# Administrative Action Preliminary Subdivision

**Case File / Name:** S-57-14 / Fairfax Section III Lots 1 & 2

**Nature of Case:** Subdivision of .51 acres into two lots, zoned Residential-4.

**OFFICIAL ACTION:** Approval with conditions

S-57-14 Preliminary Subdivision Layout

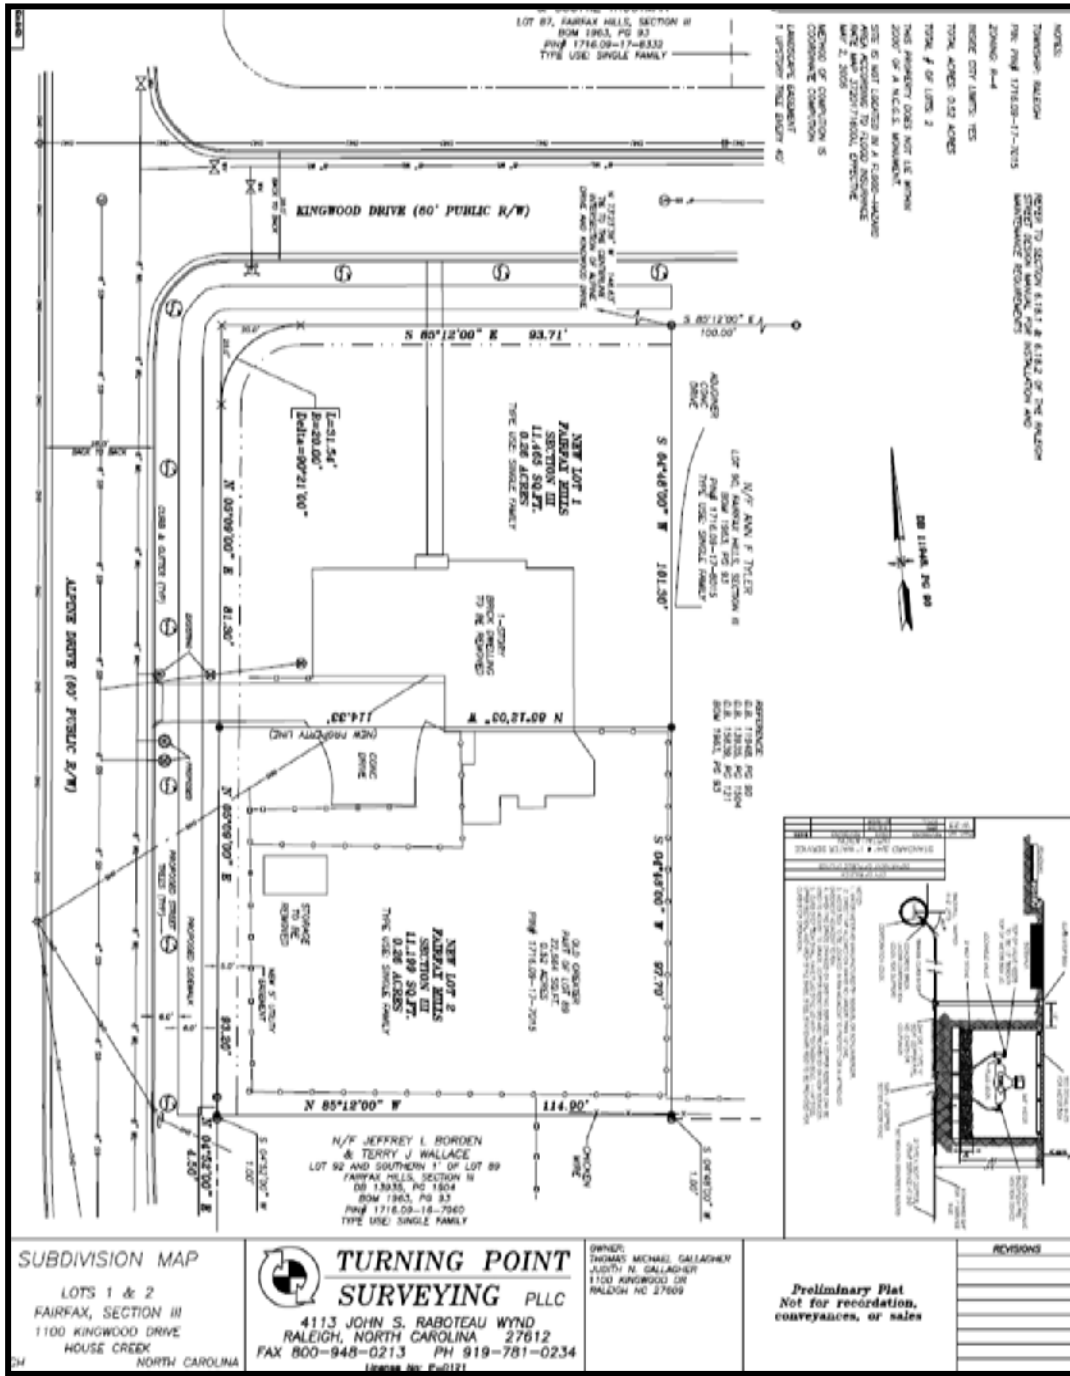
- (1) That demolition permit(s) are issued for the existing structures and the permit number(s) are shown on the plat for recording;
- (2) That if the proposed public improvements are not installed and inspected by the city to be accepted for maintenance, a surety in the amount of 125% of the cost of construction for the 6' sidewalk and streetscape trees installed on Kingwood Drive and Alpine Drive is to be paid to the Public Works Department in accordance with code section 8.1.3 of the UDO.

**STREET TYPOLOGY MAP:** Alpine Drive and Kingwood Drive are existing streets classified as Neighborhood Yields on the Street Typology Map. There is sufficient right-of-way and pavement widths on each such that no dedication or improvements are required as part of this subdivision.

**LOT LAYOUT:** The minimum lot size in R-4 zoning district is 10,000 square feet. The minimum lot depth in this zoning district is 100 feet. The minimum lot width in this zoning district is 65 feet for interior lots and 85 feet for corner lots. Lots in this development conform to these minimum standards.

- STREETSCAPE TYPE:** The applicable streetscape is residential. A 6' sidewalk and street trees will be installed in both rights-of-way as part of this development.

- PEDESTRIAN:** Proposed sidewalk locations conform to City regulations. A sidewalk is required along both Alpine Drive and Kingwood Drive. Access to the public right of way in addition to internal connection requirements is provided in accordance with 8.3.4 of the UDO.

- FLOOD HAZARD:** There are no flood hazard areas on this site.
- STORMWATER MANAGEMENT:** This site is not subject to stormwater management controls in accordance with Article 9 chapter 2 of the Unified Development Ordinance. The applicant is claiming an exemption under Section 9.2.2.A.1, for subdivisions less than one acre in aggregate size.
